Service Bulletin

All models with AK36
Chassis.

**Service
Bulletin No: 125**

SUBJECT : Q 602 defect

Hor. Transistor Driving Condition during switching ON/OFF.

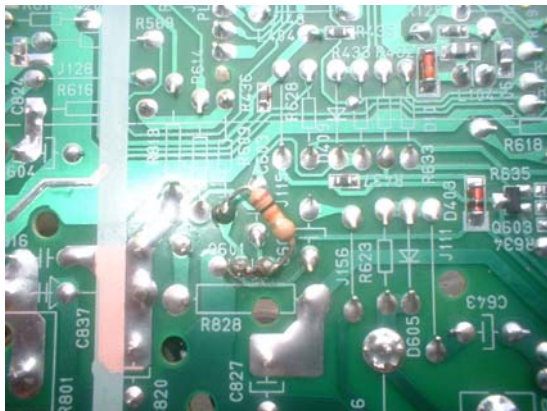
TV does not work due to Q602 broke down

After changing the defected Q602,

In order to improve Q602 resistant to sparks, modify the chassis as given below.

Solder RES CF 1/4W 10K J BETWEEN BASE AND COLLECTOR OF Q601 (Hor.driver Transistor) as shown in below.
